UNITED STATES DEPARTMENT OF COMMERCE United States Patent and Trademark Office Address: COMMISSIONER FOR PATENTS P.O. Box 1450 Alexandria, Virginia 22313-1450 www.uspto.gov

APPLICATION NO.	FILING DATE	FIRST NAMED INVENTOR	ATTORNEY DOCKET NO.	CONFIRMATION NO.
10/599,219	02/05/2007	Maurice Granger	1759.232	5939
	7590 05/11/201 IENBERG FARLEY &	EXAMINER		
5 COLUMBIA CIRCLE			NGUYEN, PHONG H	
ALBANY, NY 12203			ART UNIT	PAPER NUMBER
			3724	
			MAIL DATE	DELIVERY MODE
			05/11/2010	PAPER

#### **DETAILED ACTION**

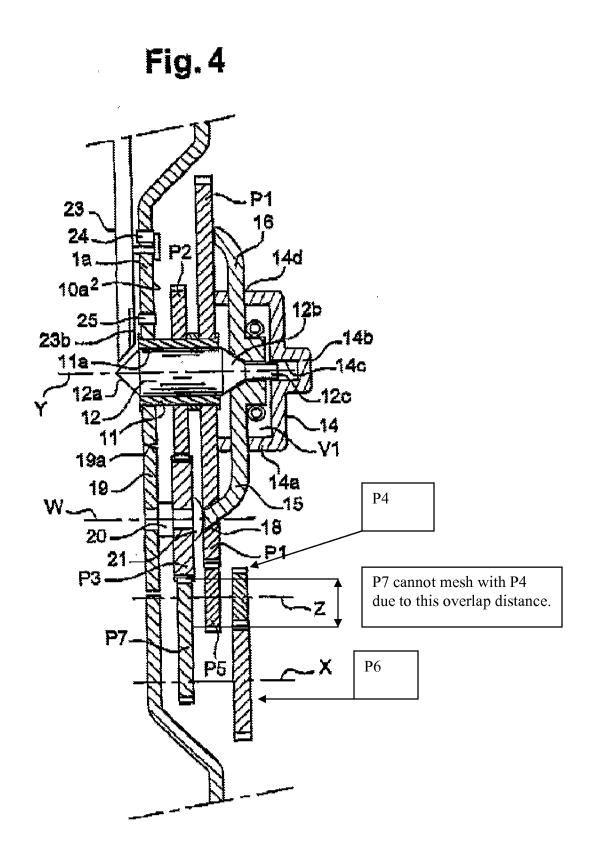
-Line 38, page 11 calls for the pinion (P7) meshing with the pinion (P4). It is unclear how it can happen. Due to fact that the center of rotation of the pinion (P7) is off its center (See Figs. 4 and 4), the pinion (P7) can pass through the pinion (P5). However,

when the pinion (P7) aligns with the pinion (P4), the pinion (P7) cannot mesh with the pinion (P4) because the length of the pinion (P7) is greater that the distance between a first point on a tooth of the pinion (P7) and a second point on the circumference of the pinion (P4).

- Line 38, page 11, it is unclear what mechanism moves the pinion (P7) to the pinion (P4).
- -Regarding the last paragraph in page 11, it appears that the paragraph describes how to dispense a small format as shown in Fig. 4. It is unclear why the pinion (P7) is displaced to the pinion (P4) since the orientation of the pinions in Fig. 4 is necessary for dispensing a small format.
- -Element 23 is called an operating lever. However, in Figs. 4 and 5, it appears that element 23 reciprocates but not pivot to be called a lever.
